**THE CITY OF PLATTEVILLE, WISCONSIN
COMMON COUNCIL AGENDA**

**THE CITY OF PLATTEVILLE, WISCONSIN
COUNCIL SUMMARY SHEET**

COUNCIL SECTION: WORK SESSION ITEM NUMBER: VIII.	TITLE: 250 East Main Street	DATE: July 30, 2024 VOTE REQUIRED: None
PREPARED BY: Howard B. Crofoot, P.E., Public Works Director

RE: 250 E Main Street, Platteville, WI
Structural Condition Assessment

Photo 1 – East wall bowing in above grade

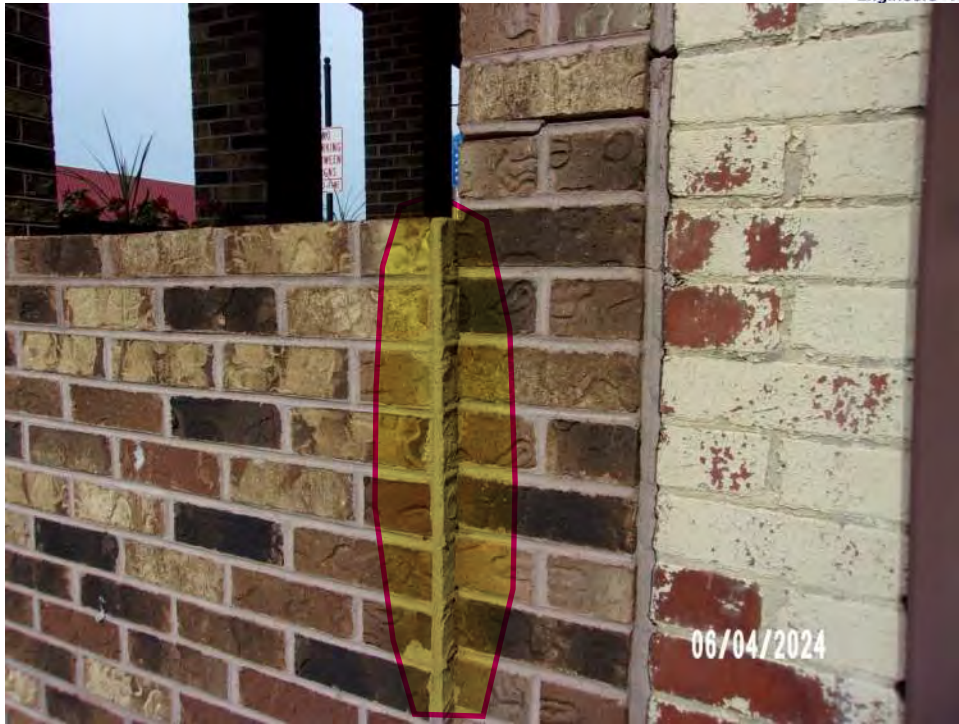
- The base of the east wall below the trim is rotted and soft. (See Photo 1 & 2)
- The east wall bows from the ground line up the main level floor structure elevation. The bow is roughly 6", with a lean of 2-3 degrees. (See Photo 1 & 2)

Photo 8 - Crack in south brick wall

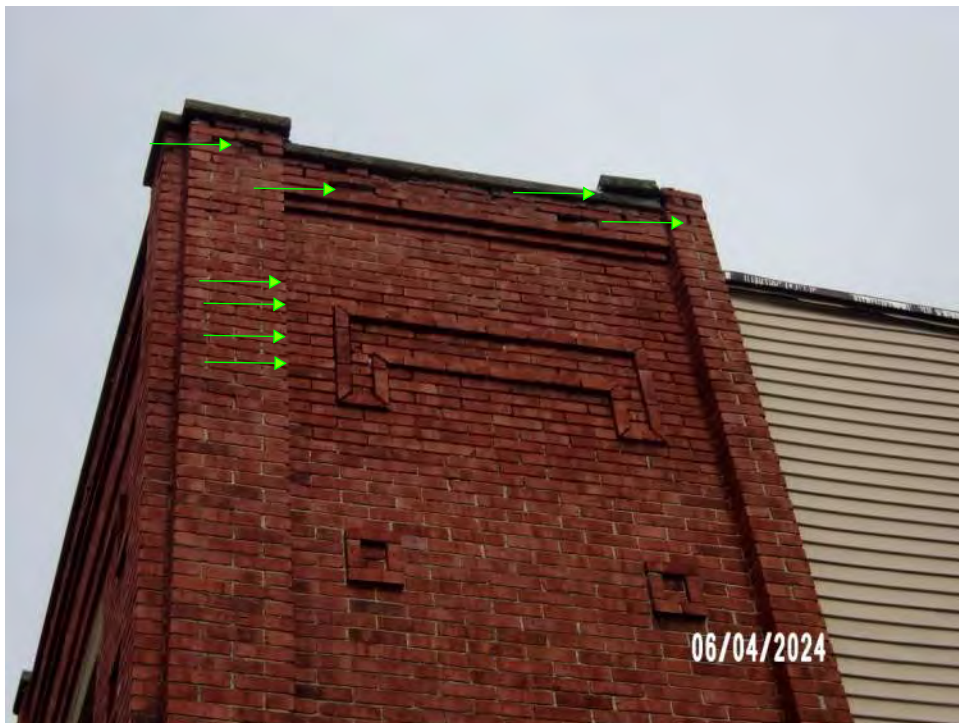
- The brick at the east end of the entry (planter wall) has shifted to the east. (See Photo 3, 4, 7)
The lower wall portion leans to the east 1 1/8" at the top. There is a 1/4" wide crack in the mortar joint. This crack extends to the south face diagonally. (See Photo 8 & 9) There is also a loss of mortar at the corbel near the ground on the southeast corner of the building. (See Photo 5 & 6)
All of this indicates that the southeast corner of the building has settled approximately 1 1/8".

Photo showing timber floor support system

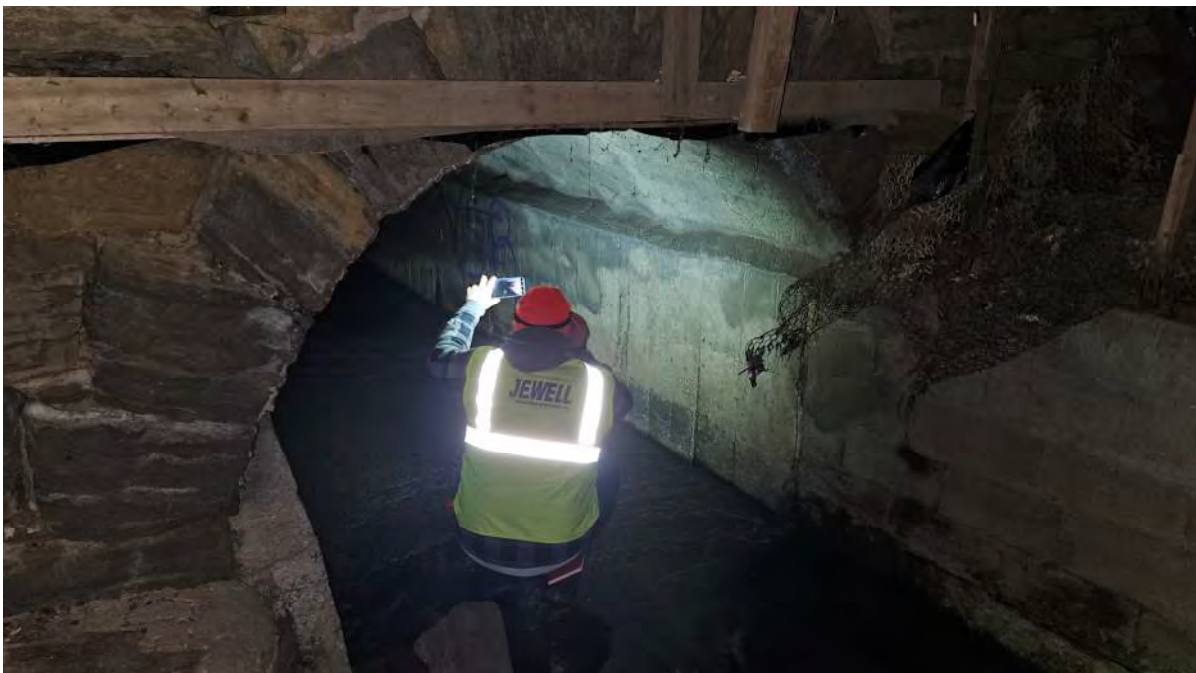
The East wall of the foundation has had a concrete wall poured adjacent to portions of the foundation on the inside. This wall appears to be supporting a wood framed beam & column system used to support a wood framed floor system. It appears that the loads from the upper walls still are transferred through the stone foundation walls.

An interior support system constructed of concrete piers, wood columns and wood beams is used to support the floor system. This interior structural system seems "cobbled together" without much thought or planning.
